# PLANNING STATEMENT ADDENDUM 20 FLAXMAN TERRACE, LONDON, WC1H 9PN

Installation on the roof 3 New VRV/VRF condenser units And Relocation Of 1 No Existing VRV/VRF condenser unit within new acoustic enclosure Ref: 2020/0941/P

These revisions have been prepared in response to comments relating to the application set out within a email from Mark Chan on the 14<sup>th</sup> May 2020, relating to Design and Climate Change. This email forms appendix 1 of this statement and its broad requirements are summarised below and responses given.

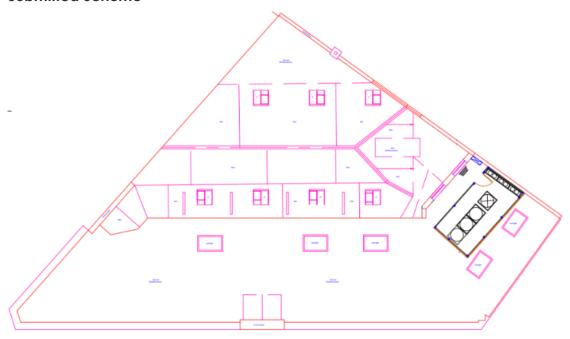
Whilst it is recognised that consideration has been given to trying to reduce the visual impact of the proposal by setting it back, away from the main frontage. the proposed enclosure is still likely have visual impact, by virtue of its scale and incongruous design. The subject building is very much of its time, is architecturally interesting, has been designed as a complete composition with a strong horizontal emphasis, and symmetrical façade. Furthermore, the external appearance of the building remains largely unaltered.

The applicant should demonstrate there is clear and convincing justification for housing the plant equipment outside the envelope of the existing building. When that is provided, special attention would then need to be paid to how to integrate the plant at rooftop level without harming the existing building's character and appearance, the local street scene along Flaxman Terrace or the appearance of the conservation area. This should take account of the policy and design guidance as set out above.

To ensure this is the case and in order to address the comments relayed by Mr Chan, design changes are proposed with the aim of minimising the visual impact of the proposal upon the host building, Flaxman Terrace itself, and its wider setting within the Bloomsbury Conservation Area.

The location of the air conditioning units and acoustic enclosure has been rotated 90 degrees anticlockwise. The locations of the original submitted scheme and the revised scheme are shown in the plans reproduced overleaf. The elevational drawing prepared by Nicola Roberts Architects submitted as part of the revised material also aids the appreciation of the level of visual impact.

The revised scheme places the units and their enclosure slightly further away from the main frontage of the building. This will result in the proposed plant and equipment being visually inconspicuous, particularly from the flats within Flaxman Court opposite. From that perspective, the proposal will sit almost behind the upper floors of No.16 Flaxman Terrace. The revised proposal is also more integrated between the adjoining elevations of No.17 Duke's Road and No.16 Flaxman Terrace, in accordance with Camden Local Plan Policy D1 Design.
